SHELIA BLOXTON FAMILY DIVISION SUBDIVISION

APPLICATION NUMBER 1 DATE February 18, 2016

REQUEST Subdivision

DETAIL SITE PLAN

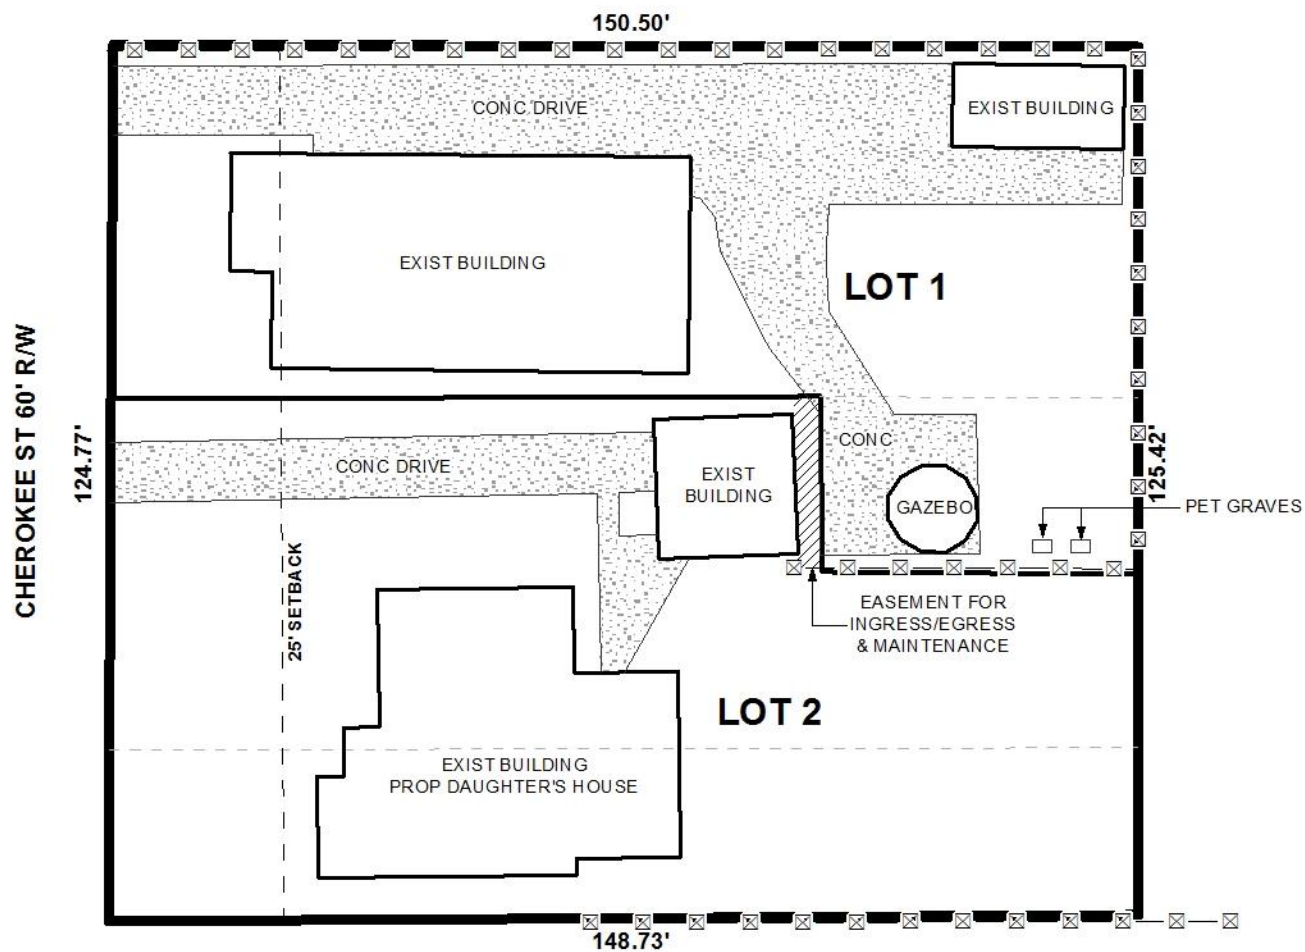
As proposed, the relocation of the common interior property line would create a Zoning Ordinance violation in that it would run along the back edge of the existing garage on proposed Lot 2 on the North-South run and not meet the required 8' rear setback. And the East-West run would be only 3.02' off the edge of the existing sunroom on proposed Lot 1 and would not meet the required 8' minimum side yard setback. No justification was submitted that would support a deviation from side and rear setbacks required by the Zoning Ordinance, and no Planned Unit Development or Variance was submitted for such.

- 1) the proposed North-South run in the common interior property line would create a violation of the 8' rear setback requirement of the Zoning Ordinance;
- 2) the proposed East-West run in the common interior property line would create a violation of the 8' side yard setback requirement of the Zoning Ordinance; and
- 3) no justification was submitted supporting the deviation from side and rear setbacks required by the Zoning Ordinance, and no Planned Unit Development or Variance was submitted to allow reduced setbacks.

The applicant submitted a revised plat relocating the proposed North-South property line approximately four feet behind the existing garage and providing an easement for ingress, egress and maintenance between the garage rear and the relocated property line. The proposed relocated East-West property line remains the same. However, this still does not provide the required 8' rear setback between the garage and property line and the proposed easement does not satisfy any setback requirements. The applicant asserts the desire to have the buried dogs and gazebo on proposed Lot.

- 1) the proposed North-South run in the common interior property line would create a violation of the 8' rear setback requirement of the Zoning Ordinance;*
- 2) the proposed East-West run in the common interior property line would create a violation of the 8' side yard setback requirement of the Zoning Ordinance regarding the gazebo;*
- 3) no justification was submitted supporting the deviation from side and rear setbacks required by the Zoning Ordinance, and no Planned Unit Development or Variance was submitted to allow reduced setbacks; and*
- 4) no justification was given to consider the proposed Subdivision as innovative.*
